June 15, 2009
NRC:09:067

Response to a Request for Additional Information Regarding ANP-10286P, "U.S. EPR Rod Ejection Accident Methodology Topical Report"

**Response to a Request for Additional Information – ANP-10286P
“U.S. EPR Rod Ejection Accident Methodology Topical Report”**

Figure 36-1—SPERT III-E Test 60 Ejected Control Rod Worths

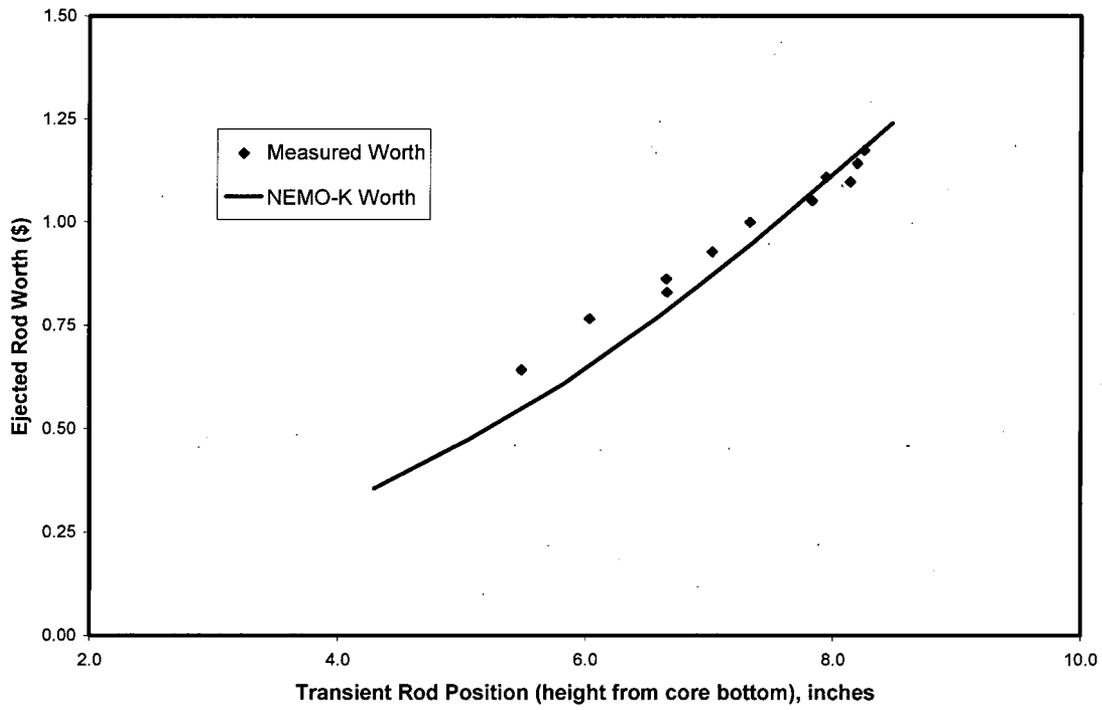
RAI-36. *In order to assess the NEMO-K/LYNX-T Computational Engine reactivity insertion accident analyses, we request that AREVA perform comparison analyses of reactor excursion tests performed during the mid-1960s at the National Reactor Testing Station. These data were taken during the E-Core campaign as part of the Special Power Reactor Test III (SPERT) program. This comparison analysis will assist the verification of compliance of the rod ejection analysis with the Standard Review Plan (SRP), Section 15.4.8.*

The base neutronic model is validated with two static comparisons. First, the hot zero power (HZP) static control rod worths at 500°F versus the initial position are calculated and compared

in Figure 36-1 to the measured test results from Reference 2. Second, the calculated moderator temperature coefficient (MTC) is $-3.8\phi/^{\circ}\text{F}$ and the measured MTC is listed as $-4.0\phi/^{\circ}\text{F}$. The agreement with the measured results is good (within 5%) and indicates that the assumptions made are reasonable.
